Kensington Safe Streets

Phase 2 Public Consultation Report
August 2022

Artist rendering of the preliminary design proposal for Augusta Avenue

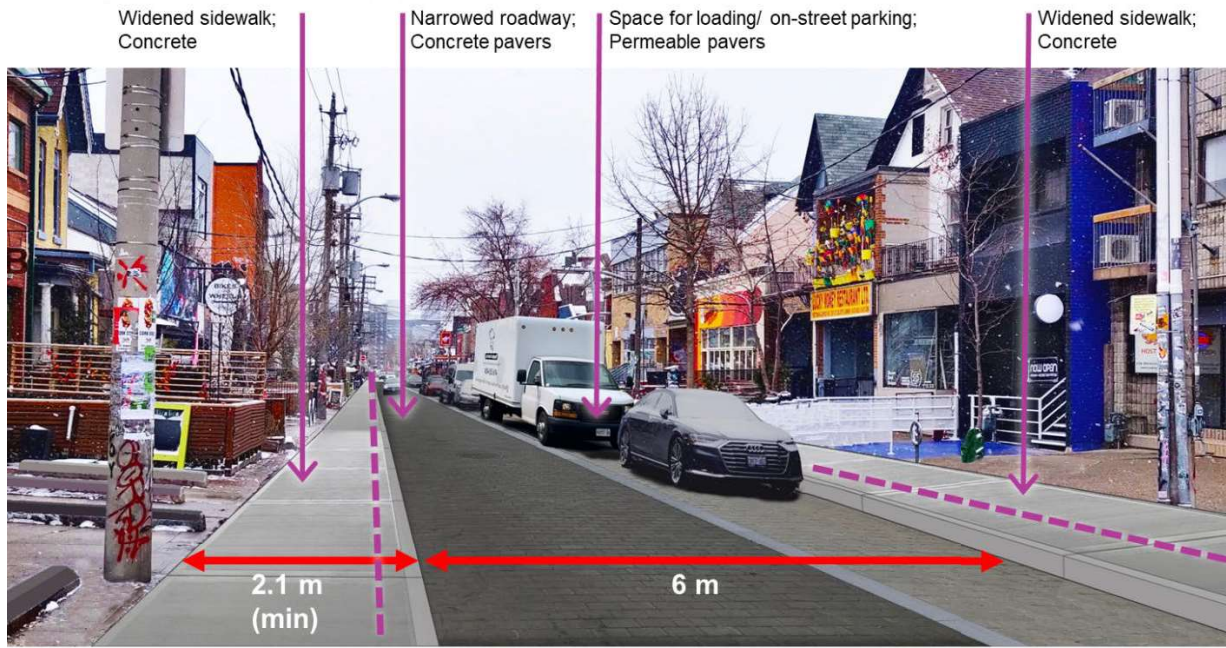
Topic	Comment Summary
Accessibility	<ul style="list-style-type: none"> • Narrowing the roadway would impact accessibility negatively • Disabled permit holders could park in No Parking areas and roadway would still be wide enough to allow through traffic • Do not remove disabled parking on the east side of Augusta
Construction	<ul style="list-style-type: none"> • Concerned about how long construction would take and the impact to local businesses during an already difficult time
Cycling	<ul style="list-style-type: none"> • Cyclists needed more space; Narrowing the roadway would lead to less space for cyclists to avoid traffic • There was no dedicated cycling infrastructure in this plan • Replace the parking lane with a bike lane
Greenery	<ul style="list-style-type: none"> • There should be more greenery and trees
Material	<ul style="list-style-type: none"> • Concrete pavers would make the road bumpy for cyclist and would not be maintained • The City should not designate public space just for parking with contrasting pavers • Sidewalks should have a nicer finish than generic concrete • Concrete sidewalk would get slippery during the winter

Narrowed roadway	<ul style="list-style-type: none"> • A narrower roadway would aggravate road congestion • The narrow roadway could be an issue for fire, delivery and emergency vehicles • The lack of room for standing vehicles on the other side would create chaos; delivery-only hours are needed in the morning
Parking	<ul style="list-style-type: none"> • There was too much parking in the proposed design • Parking should be reduced or removed • Parking spaces should only be for delivery and disabled parking • Delivery should be time-restricted • Cars regularly park illegally on both sides, widening would not solve the mobility issue
Pedestrianisation	<ul style="list-style-type: none"> • Close the street to non-delivery traffic • Make Kensington Market car-free and pedestrianised • Make the area pedestrian only on weekends
Shared street	<ul style="list-style-type: none"> • Augusta Avenue should be curbside • The street should become a mixed-use shared street with bollards • There was too much visual clutter with the red parking lane

Sidewalks	<ul style="list-style-type: none"> • Sidewalks should be wider to accommodate higher volumes of pedestrian traffic

<ul style="list-style-type: none"> • Pedestrians should get the most space
Through traffic	<ul style="list-style-type: none"> • Augusta currently being used as a shortcut to avoid Bathurst • Do not allow drivers to have a straight path that encourages speeding • Still too many cars on Augusta, it should not be a throughway from Dundas to College • Non-local traffic driving through Kensington
Other	<ul style="list-style-type: none"> • Garbage collection • Snow removal • Lack of street benches • Ideally no overhead wires • Streetlights should be replaced, they still looked very utilitarian • Add artistic features, such as hanging string lights or hanging white light balls

Artist rendering of the preliminary design proposal for Kensington Avenue

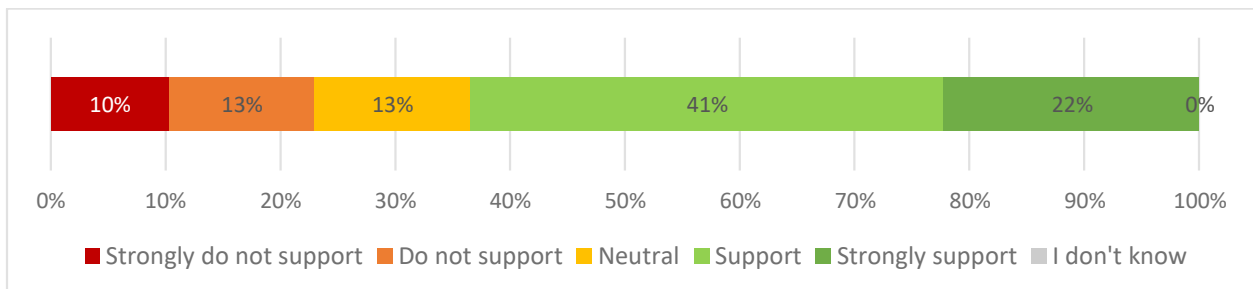
Topic	Comment Summary
Cycling	<ul style="list-style-type: none"> • Cyclists and drivers would be competing for the same space • Designated cycling facilities are needed • Toronto’s standard bike corrals look out of place and low quality • Signage to remind drivers to share the road with cyclists • Replace parking with bike lane
Greenery	<ul style="list-style-type: none"> • More trees needed • If the parking spaces were made diagonal, there would be space for greenery
Material	<ul style="list-style-type: none"> • Concerned about the durability of pavers • Pavers would not be friendly for cyclists • Pavers would look terrible and become a safety hazard in a few years if not maintained • Sidewalk material should not be concrete if the roadway was built of quality materials
Parking	<ul style="list-style-type: none"> • Parking not needed • Parking should be reduced or removed • Parking spaces should only be for residents, delivery and disabled parking • Delivery should be time-restricted • Parking spaces should be used for wider sidewalks and for patios

Pedestrianisation	<ul style="list-style-type: none"> • Close the street to non-delivery traffic • Make Kensington Market car-free and pedestrianised • Make the area pedestrian only on weekends

Shared street	<ul style="list-style-type: none"> • Too much pedestrian traffic on Kensington to give precedence to cars • Make the street a woonerf and curbless • The street should become a mixed-use shared street with bollards • There would be too much visual clutter with the red parking lane
Sidewalks	<ul style="list-style-type: none"> • Remove illegal A-frame signs on the sidewalks • Sidewalks should be widened • Include bollards to stop drivers from parking illegally on sidewalks
Traffic calming	<ul style="list-style-type: none"> • Install speed bumps to slow down traffic
Other	<ul style="list-style-type: none"> • Garbage collection • Snow removal • Streetlights should be replaced, they still looked very utilitarian • Add artistic features, such as hanging string lights or hanging white light balls

Artist rendering of the preliminary design proposal for Nassau Street

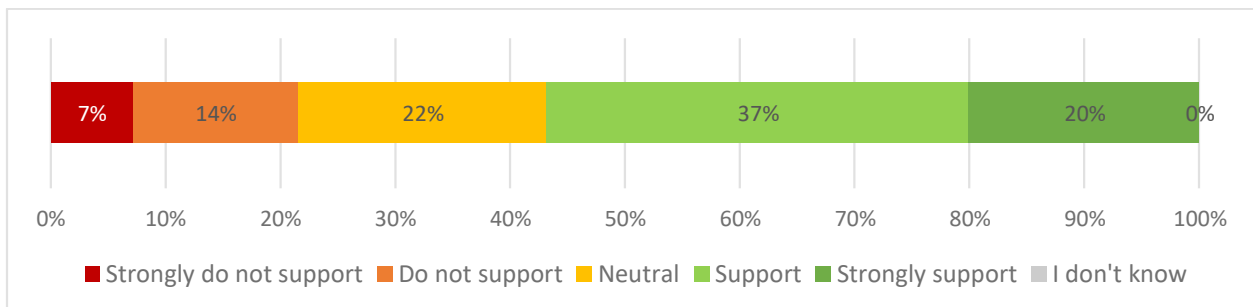
Topic	Comment Summary
Cycling	<ul style="list-style-type: none"> • The bike share station seemed disconnected from the bike network, there should be a bike lane and less parking • Change the orientation of the bike share station to have riders back out and dock bikes on the sidewalk • Shared bike lane markers, a contraflow bike lane or bidirectional bike lanes should be considered • There should be more room for bike infrastructure, such as bike parking • Cyclists would block vehicular traffic
Greenery	<ul style="list-style-type: none"> • There should be more trees for shade
Material	<ul style="list-style-type: none"> • It felt generic and utilitarian, especially the concrete sidewalks; would prefer a traditional strip of red bricks or granite pavers along the gutter at the curbs • Asphalt would contribute to the urban heat island effect • The roadway should be all permeable pavers • The change in materials would not prevent collisions for cyclists and pedestrians

Narrowed roadway	<ul style="list-style-type: none"> • Delivery trucks unloading would cause gridlock because of the narrowed roadway

Parking	<ul style="list-style-type: none"> Remove or reduce parking Use the parking space for wider sidewalks and patio space Provide loading zones for pick up, drop off and deliveries
Pedestrianisation	<ul style="list-style-type: none"> Too much space was dedicated to parking The street and the market should be pedestrianised
Shared street	<ul style="list-style-type: none"> This should be a shared street or woonerf and could allow for parking
Sidewalks	<ul style="list-style-type: none"> There was not enough sidewalk space to support foot traffic and discourage car use in the area Sidewalks should be widened further on both sides Concerned about the increased sidewalk width as the road was already narrow as it was
Through traffic	<ul style="list-style-type: none"> The street was used as a shortcut from Bathurst and the hospital to Spadina and was too busy for pedestrian safety Drivers were driving dangerously fast along this street Speed bumps were not enough of a deterrent, the direction should be reversed between Bellevue and Augusta

Other	<ul style="list-style-type: none"> Snow removal Garbage collection Streetlights still looked very utilitarian and should be replaced There should be more decorations or ornamental features such as paving, plantings, and lighting

Artist rendering of the preliminary design proposal for St. Andrew Street

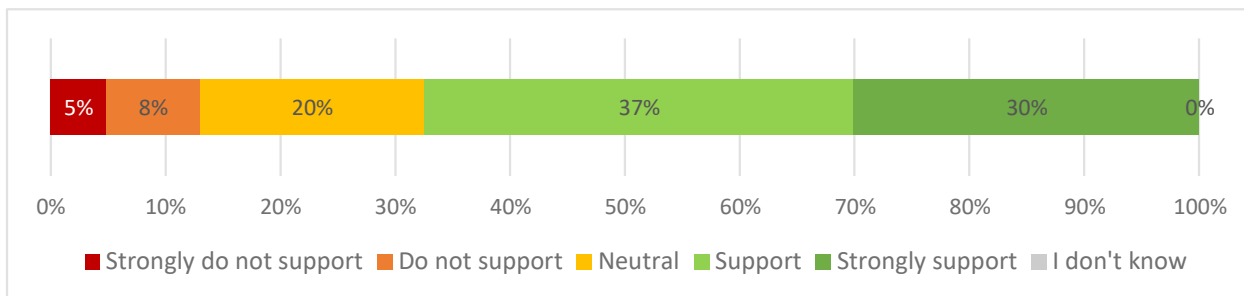
Topic	Comment Summary
Cycling	<ul style="list-style-type: none"> • There should be a bike lane • Not having a defined space for cyclists meant they would be mixing with car traffic
Greenery	<ul style="list-style-type: none"> • There was too much concrete and too little greenery in the design • There should be more trees, especially native and fruit trees • Silva cells and irrigation for trees would be preferred

Material	<ul style="list-style-type: none"> • St. Andrew was often a forgotten street, it should have the same treatment as other commercial streets like Kensington and Baldwin • Asphalt was not preferred, it should be replaced with more sustainable materials • The concrete sidewalk should be changed to another material
Narrowed roadway	<ul style="list-style-type: none"> • The roadway was still too wide, it should be matched with other streets in the market
One-way street	<ul style="list-style-type: none"> • It should be converted into a one-way street, giving more space to pedestrians and CafeTO spaces
Parking and loading	<ul style="list-style-type: none"> • This street should be the focal point of truck delivery and loading, there should be more loading spaces • Remove parking spaces • Change the No Stopping signage to No Parking to allow legal parking by disabled permit holders • There should be loading hours in the morning for large trucks

Pedestrianisation	<ul style="list-style-type: none"> • Close the street to non-delivery traffic • Make Kensington Market car-free and pedestrianised • Make the area pedestrian only on weekends
Shared street	<ul style="list-style-type: none"> • This should be a shared street • Remove curbs, use bollards instead
Sidewalks	<ul style="list-style-type: none"> • Sidewalks should be widened • There were too many obstacles for wheelchair users • Benches looked very utilitarian and prone to graffiti
Traffic calming	<ul style="list-style-type: none"> • Consider traffic calming measures for the parking garage on the north side, cars often cut pedestrians off
Other	<ul style="list-style-type: none"> • Snow removal • Garbage collection • Lack of street benches • Better lighting

3 preliminary design options were presented for Baldwin Street:

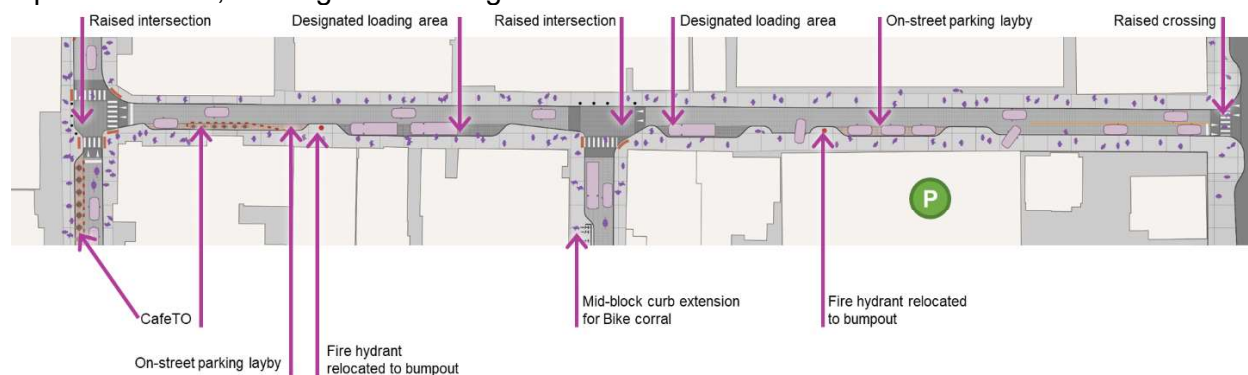
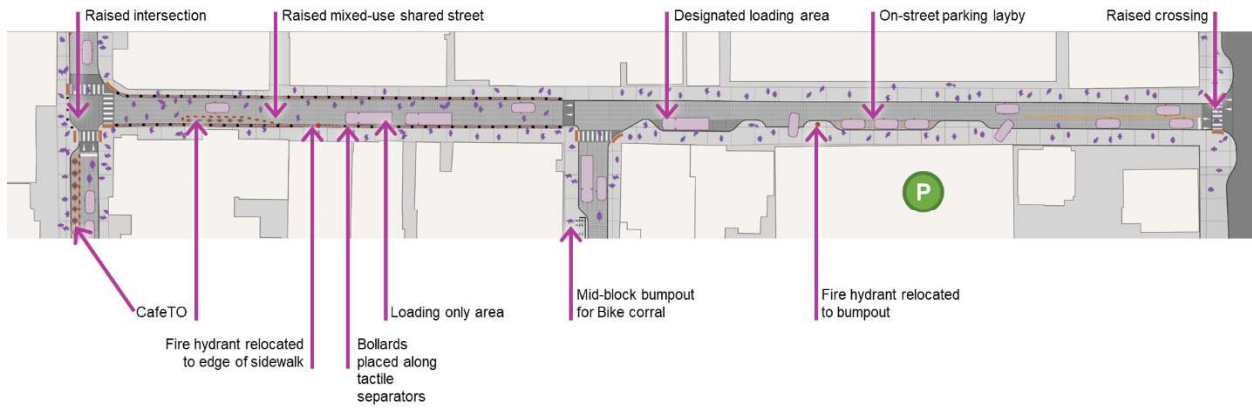
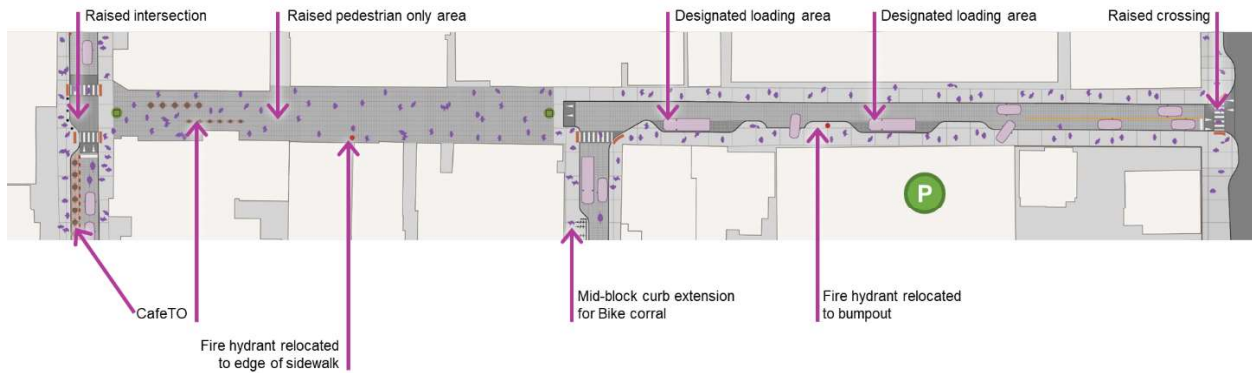
Topic	Comment Summary
Accessibility	<ul style="list-style-type: none"> • Add wheelchair accessibility features • Increase pedestrian space
CafeTO	<ul style="list-style-type: none"> • Add more CafeTO space
Cycling	<ul style="list-style-type: none"> • There should be separated and protected bike lanes • Add bike racks and repair station <p>Option 1:</p> <ul style="list-style-type: none"> • The bumpouts would not offer additional pedestrian space or green space, it would be better to use the space for bike parking <p>Option 2:</p> <ul style="list-style-type: none"> • Designate cycling on the other side of the bollards away from car traffic <p>Option 3:</p> <ul style="list-style-type: none"> • Cycling should be allowed on the pedestrian only street

<ul style="list-style-type: none"> • Add painted bike lanes
Greenery	<ul style="list-style-type: none"> • Add trees to provide shade • Add landscaping along the pedestrian area
Material	<ul style="list-style-type: none"> • Use quality materials, better streetlights and public art to signify this area as the heart of Kensington <p>Option 2:</p> <ul style="list-style-type: none"> • Use colourful bollards that would not easily be damaged • Replace bollards with bike rings and ensure wheelchair accessibility
Parking and loading	<p>Option 1:</p> <ul style="list-style-type: none"> • Designate loading areas during 7 a.m. to 12 p.m. only • Remove or reduce parking; only maintain loading areas • All the parking should be maintained; have fewer truck loading bays and have loading hours only for large trucks <p>Option 3:</p> <ul style="list-style-type: none"> • Delivery trucks should be able to access the pedestrianised area; use bollards that shopkeepers could collapse for delivery vehicles • The plan was too rigid and would penalize grocers who rely on loading areas to receive their products daily • Concerned about the lack of loading areas for businesses • A shared street seemed to be more appropriate and a happy balance in terms of loading • Concerned about garbage removal • Maintain on-street parking

Shared street / Pedestrianisation	<p>Option 1:</p> <ul style="list-style-type: none"> • This street and the market should be pedestrianised • Option 1 was a regressive car-centric view of the world; it would be reasonable to expect people to park their cars outside of Kensington Market and walk • Do not have ambiguous relationships between cars, deliveries and pedestrians • Make this a shared street <p>Option 2:</p> <ul style="list-style-type: none"> • Still prefer Option 3 for full pedestrianization • Pedestrian only streets were sorely missing from Toronto • Concerned about the level of pedestrianization, that anywhere from 10-25 people would all have to move out of the way for one car to pass; would prefer Option 3 • There were good design elements but Option 3 was still superior • Make the street pedestrian only after 11:00 a.m. <p>Option 3</p> <ul style="list-style-type: none"> • Toronto needed 'European style' pedestrian malls, it would make the city more vibrant and animated • This would be the best way to activate Kensington Market and draw more people into the space • Prefer Option 2 as it would be balanced for everyone

Raised intersection	<ul style="list-style-type: none"> • There should be a raised intersection at Kensington Avenue

Public art	<ul style="list-style-type: none"> • Allow artists to paint murals on the road surface every month
Safety	<p>Option 2:</p> <ul style="list-style-type: none"> • This option would not work for Toronto’s dangerous driving culture; the sidewalks would be too narrow and there would be accessibility issues of forcing people to share a street with dangerous drivers • Having only 1 block of shared street would be confusing and dangerous • The street was shared now and it was dangerous, noisy, dirty, cramped and not functional for everyone • The shared street would still be wide enough to encourage speeding and through traffic • Ensure there would be sufficient signage <p>Option 3:</p> <ul style="list-style-type: none"> • Install barriers to protect pedestrians from vehicles • Drivers turning in from Spadina trying to get to Augusta would be confused or upset
Scope	<p>Option 2:</p> <ul style="list-style-type: none"> • Expand the scope of shared street to Spadina Avenue • Apply the same treatment to other streets <p>Option 3:</p> <ul style="list-style-type: none"> • Expand the scope of pedestrianised street to Spadina Avenue • Make the section between Kensington Avenue and Spadina Avenue a shared street to allow for delivery and loading • Apply the same treatment to other streets

Other	<ul style="list-style-type: none"> • Install public toilets within the pedestrian only area • Incorporate features like seating, places to eat and rain cover • Ensure a farmers market could take place

Designated Loading Areas

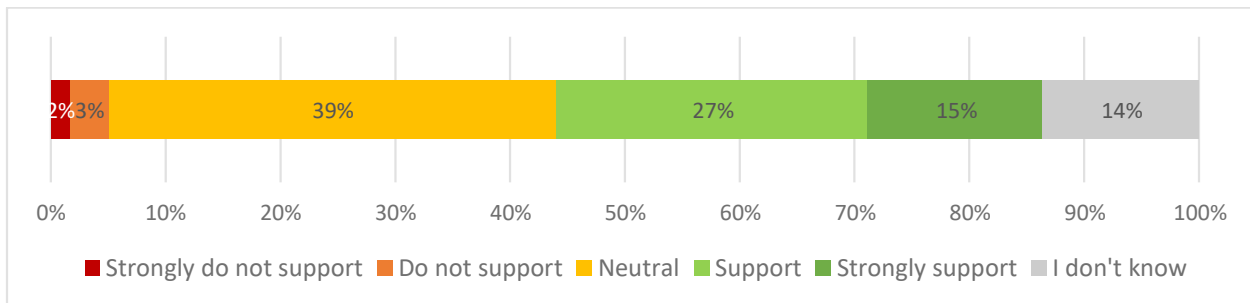
Topic	Comment Summary
Bollards	<ul style="list-style-type: none"> Install bollards on all streets to prevent trucks from jumping the curb Use pop-up bollards to coordinate access and allow only delivery vehicles

Enforcement	<ul style="list-style-type: none"> • Concerned about the ability to enforce the loading zones as it seemed like a free-for-all situation • Any new loading zones must be easy to access and understand
Excessive space	<ul style="list-style-type: none"> • The number of proposed loading areas seemed excessive • Consider reducing the number of hours or consolidating the areas to maintain the current hours • Truck drivers would have forklifts and other equipment to move products along sidewalks to their destinations
Insufficient space	<ul style="list-style-type: none"> • It did not seem enough for the deliveries as the semis already had a difficult time getting through the market and this would be a lot tighter
Loading hours	<ul style="list-style-type: none"> • Loading hours should take place overnight until early morning to minimize disruption • Remove vehicular access after loading hours • Some businesses would benefit from an earlier start than 7 a.m.

Location-specific	<ul style="list-style-type: none"> • Loading zone would be needed on the north side of Nassau, just east of Augusta; and the CafeTO installation should be relocated • Loading zone would be needed on the south end of Augusta for businesses south of the park • There were too many loading zones concentrated at the top end of Kensington; businesses on St. Andrew were often blocked by trucks all day • Baldwin between Kensington and Spadina was the most congested for loading issues
Parking	<ul style="list-style-type: none"> • The trade-off for more loading areas should be at the cost of parking and road space for drivers, not pedestrian space • Loading should be allowed but not parking • Too much space was dedicated to parking, which would prevent trucks from loading safely without blocking sidewalks or being too far from their destination • Loading zones should revert to street parking after the loading hours

Pedestrianisation	<ul style="list-style-type: none"> • Loading areas should not be an obstacle to pedestrianised or shared streets • The entire design should be rethought to prioritize pedestrians and cyclists • Streets should be made car-free while allowing for local access and deliveries
